Customs Convention on the International Transport of Goods under Cover of TIR Carnets (TIR Convention, 1975):

Amendment proposals to the Convention: Vehicles with sliding sheets

Vehicles and containers with sliding sheets

Submitted by the International Association of the Body and Trailer Building Industry

Sketch No. 9.4.

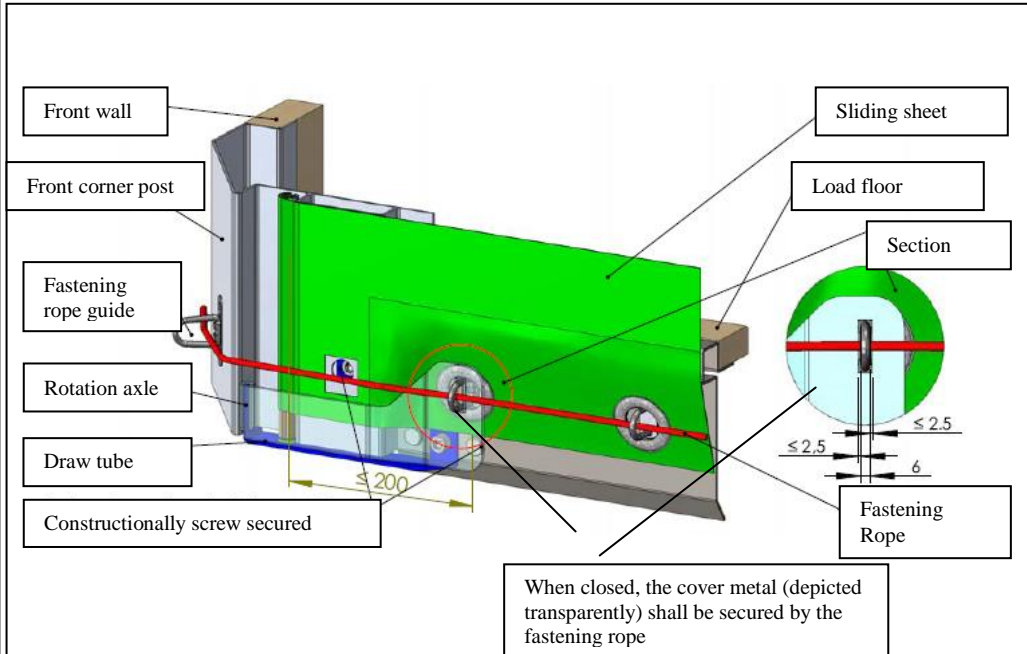
7. For the existing sketch No. 9 substitute

To tighten the sliding sheets in the horizontal direction, a ratchet gear is used (normally at the rear end of the vehicle). This sketch shows two examples, (a) and (b), of how the ratchet or gearbox may be secured.

When closed, the cover metal (depicted transparently) shall be secured by the fastening rope

Sketch No. 9.5

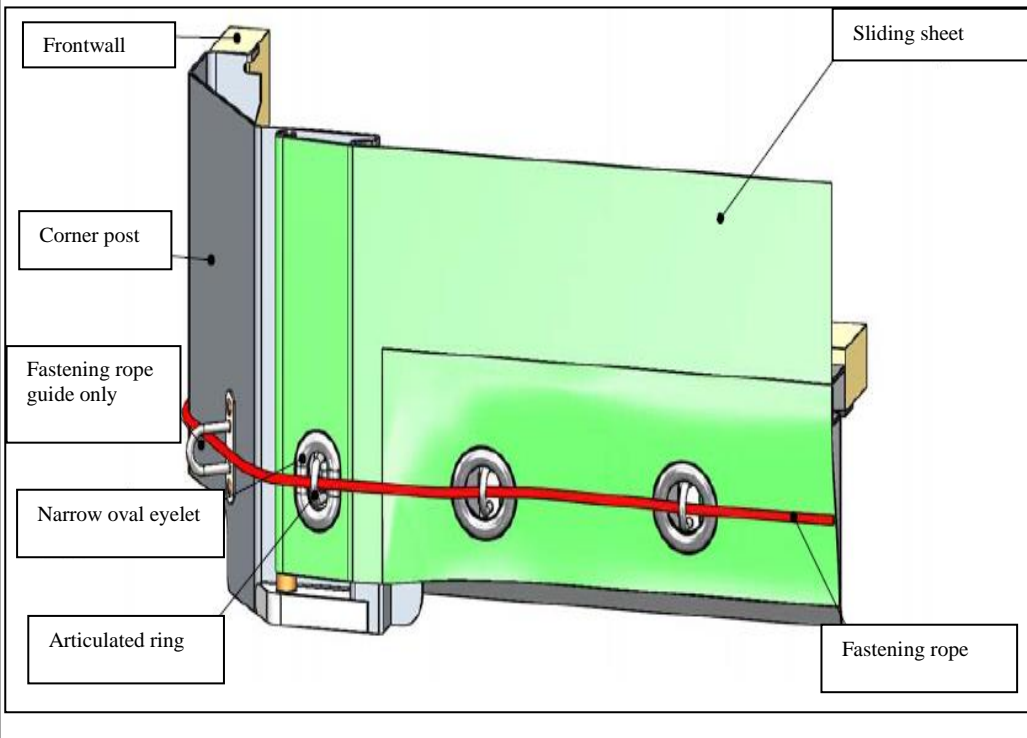
To fix the sliding sheet on the other side (normally the front of the vehicle), the following systems, (a) or (b), may be used.

Sketch No. 10

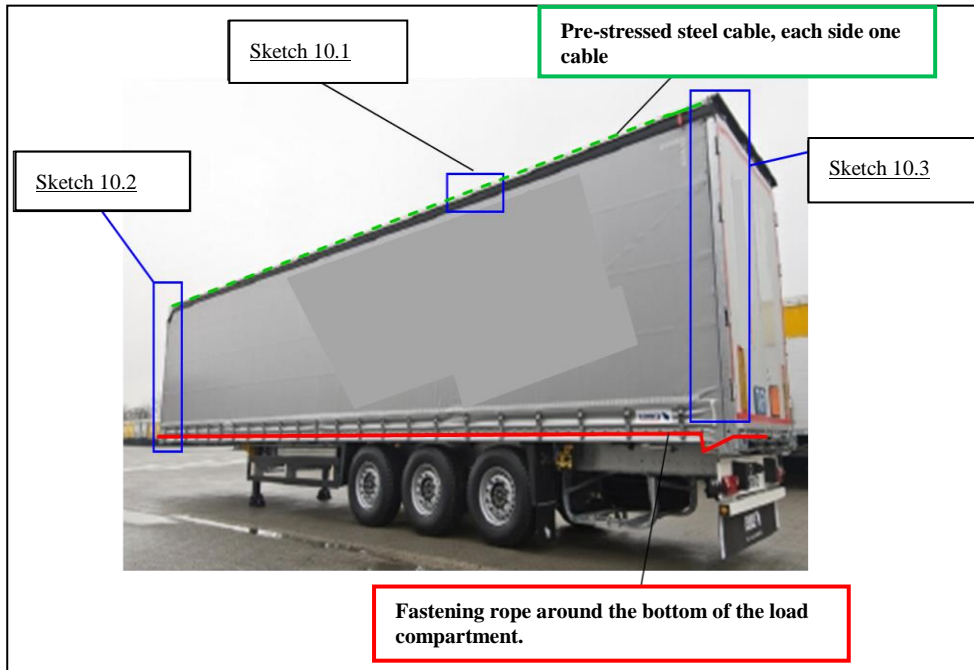
8. Add the following new sketch to the existing sketches appended to Annex 2

This sketch shows an example of a vehicle and the important requirements described in Article 5 of these Regulations.

Sketch No. 10.1

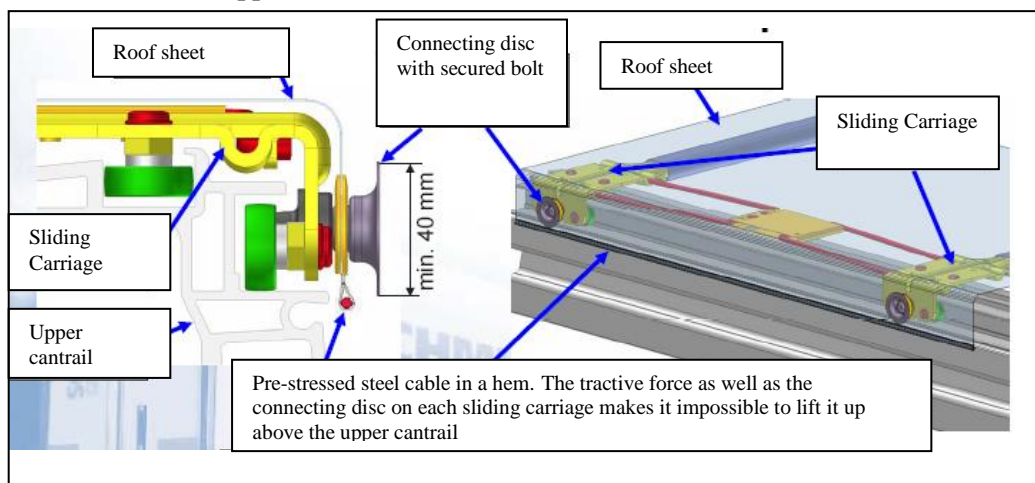
Two pre-stressed steel cables, embedded in a hem, are fixed on each side of the load compartment. This pre-stressed steel cable is fixed to the front (see sketch 10.2) and rear of the body (see sketch 10.3). The tractive force as well as the connecting disc on each sliding carriage makes it impossible to lift up the hem with the pre-stressed steel cable above the upper cantrail.

Sketch No.10.2

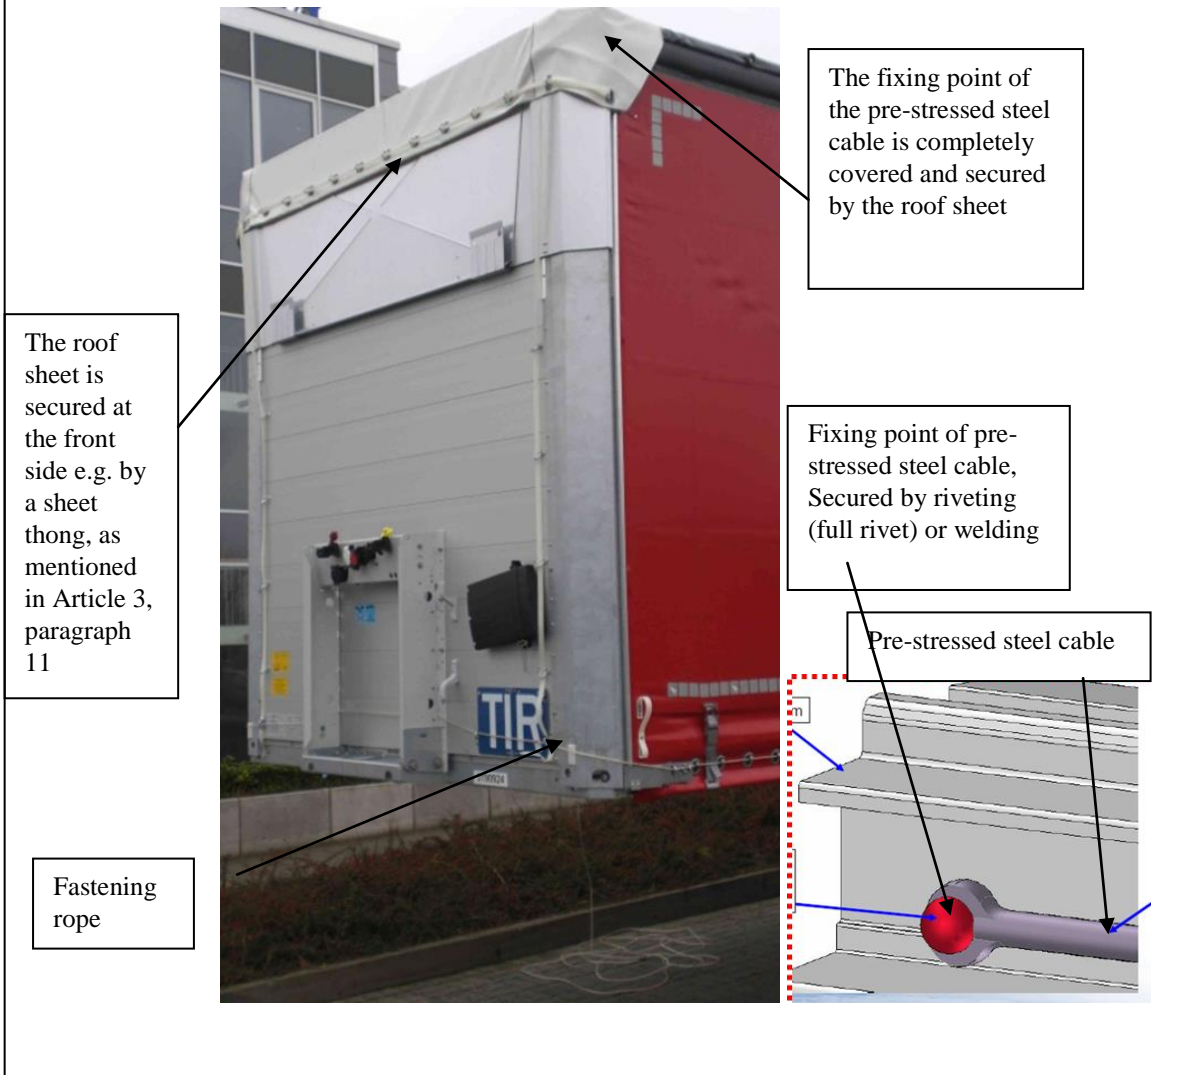
The roof sheet overlaps with the solid part of the roof so that the roof sheet cannot be pulled over the top edge of the upper cantrail.

Sketch No 10.3

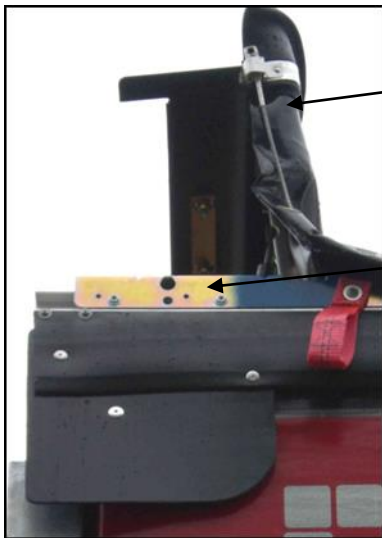
At the rear, a special device, such as a baffle plate, is fitted to the roof, preventing access to the load compartment, without leaving obvious traces when the doors are closed and sealed.

The fixing point of the pre-stressed steel cable is completely covered, and the metal cover is secured by welding or riveting (full rivet)

Sketch No. 9.4.

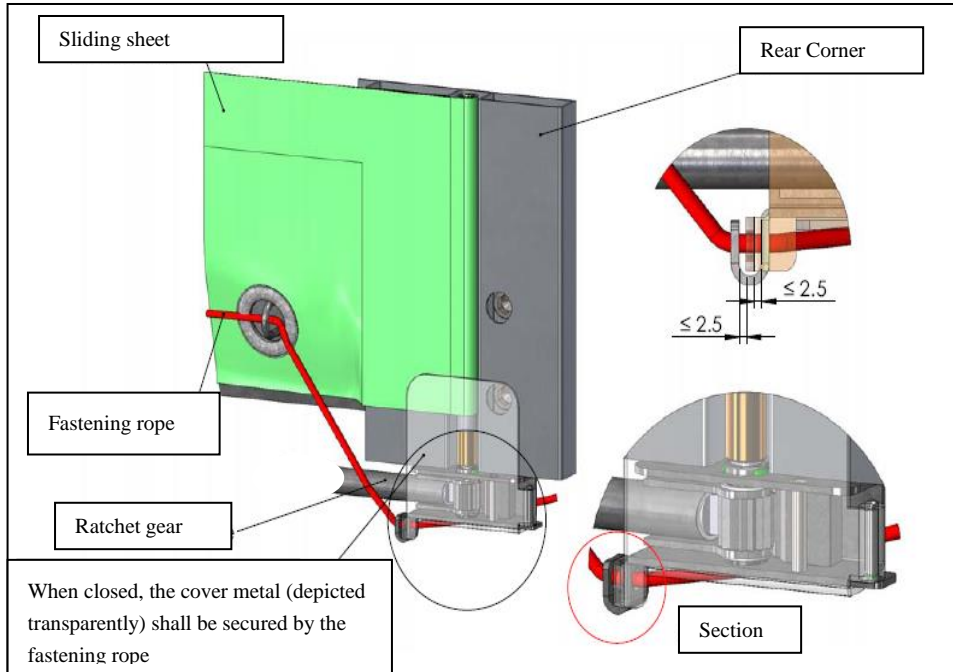
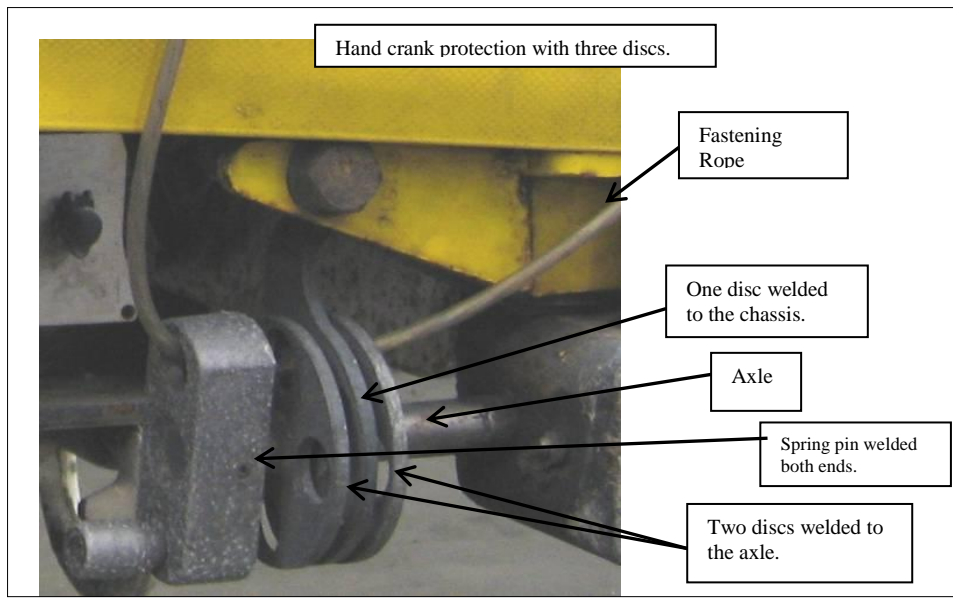
12. For the existing sketch No. 9 substitute

To tighten the sliding sheets in the horizontal direction, a ratchet gear is used (normally at the rear end of the vehicle). This sketch shows two examples, (a) and (b), of how the ratchet or gearbox may be secured.

Sketch No. 9.5

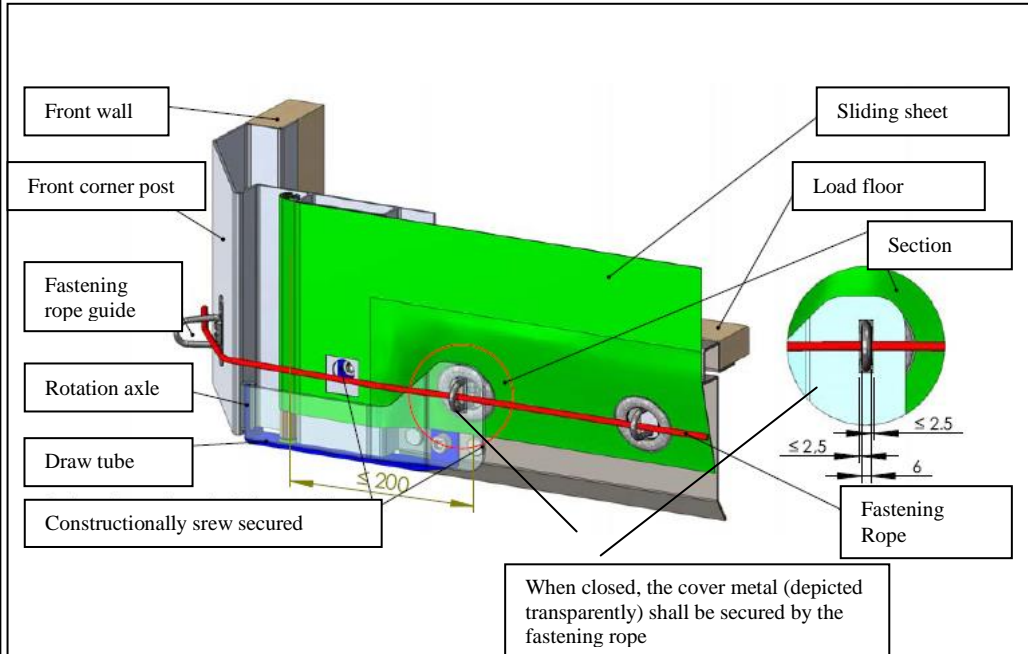
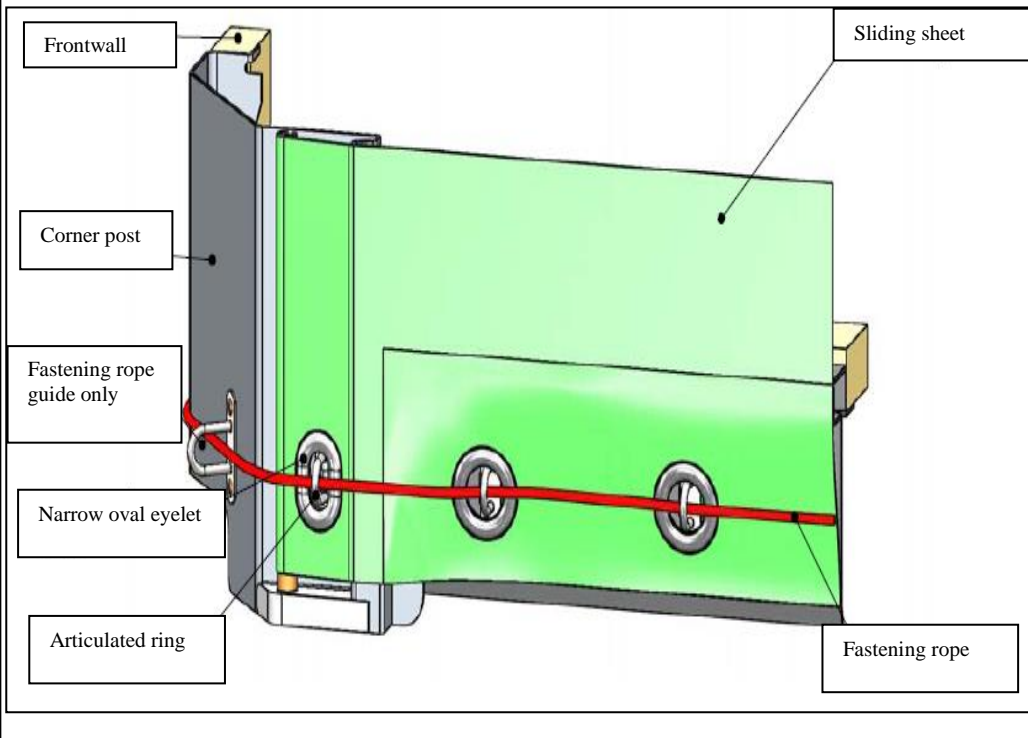
To fix the sliding sheet at the other side (normally the front of the vehicle), the following systems, (a) or (b), may be used.

Sketch No. 10

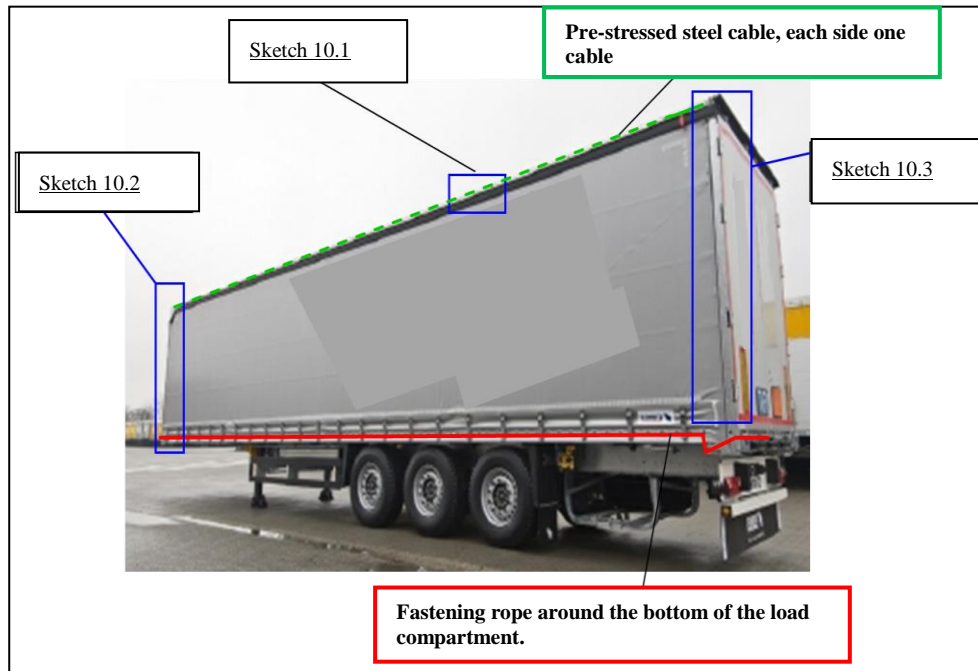
8. Add the following new sketch to the existing sketches appended to Annex 7, Part I

This sketch shows an example of a vehicle and the important requirements described in Article 6 of these Regulations.

Sketch No. 10.1

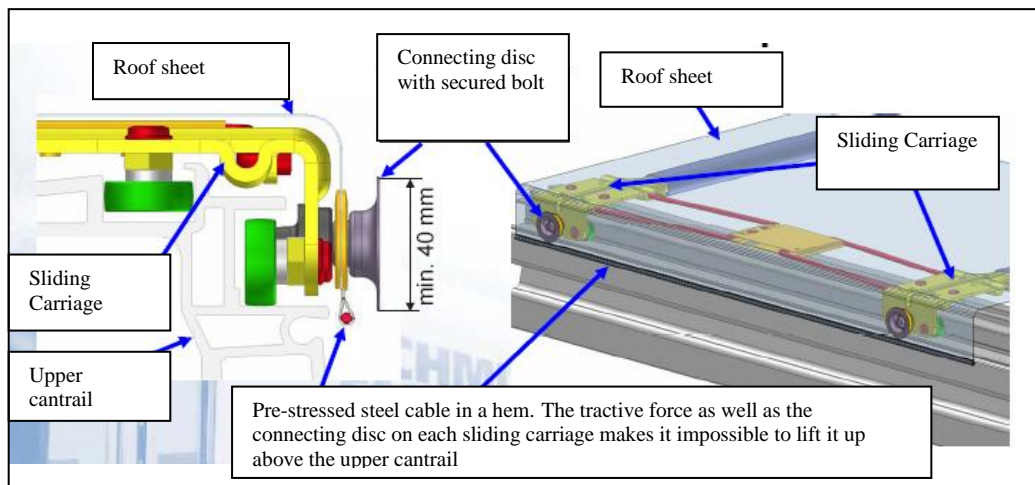
Two pre-stressed steel cables, embedded in a hem, are fixed at each side of the load compartment. This pre-stressed steel cable is fixed to the front (see sketch 10.2) and rear of the body (see sketch 10.3). The tractive force as well as the connecting disc on each sliding carriage makes it impossible to lift up the hem with the pre-stressed steel cable above the upper cantrail.

Sketch No.10.2

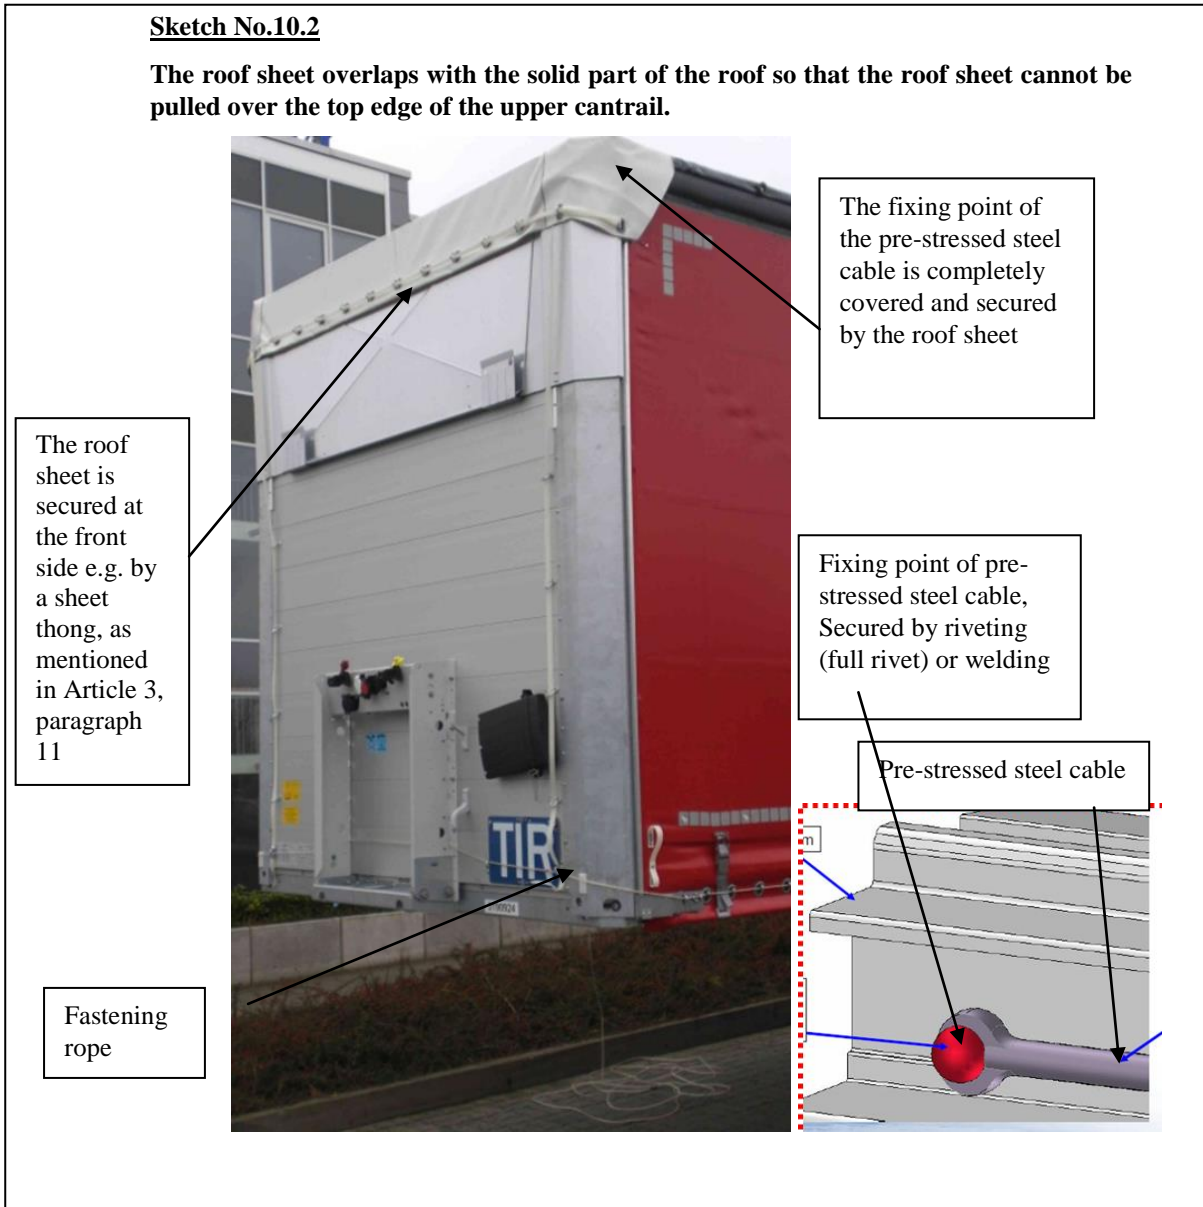
The roof sheet overlaps with the solid part of the roof so that the roof sheet cannot be pulled over the top edge of the upper cantrail.
